**Re: Notice of Exhibition - New High School at Edmondson Park (SSD - 62028458)**

Liverpool City Council was invited to provide comments to the notification of a State Significant Development (SSD-62028458) for the development of a high school at 145 Buchan Avenue, Edmondson Park (Lot 2 in DP1287903). The proposed development includes the construction of four new buildings ranging in height from one to five storeys, onsite carparking, associated earthworks and infrastructure over two stages and a capacity of 2,000 students.

Figure: Entrances between the primary school and the proposed high school.

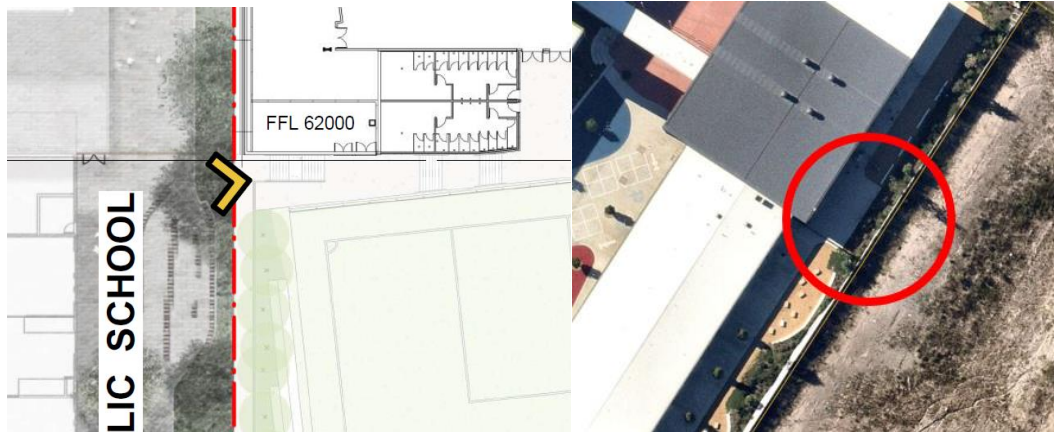
- Council supports the design seeking to connect the proposed high school with the existing primary school. However, the proposal has not provided any connected space between the two educational institutions. Two entrances towards the Oval and Gym are proposed, but they are lacking definition of boundaries, fencing or details to show how these entrances come together. Refer to the image below.

6. Details addressing the interface works between the primary and high school should be provided. Where possible cohesive open spaces between the two schools should be provided rather than the provision of gates only.
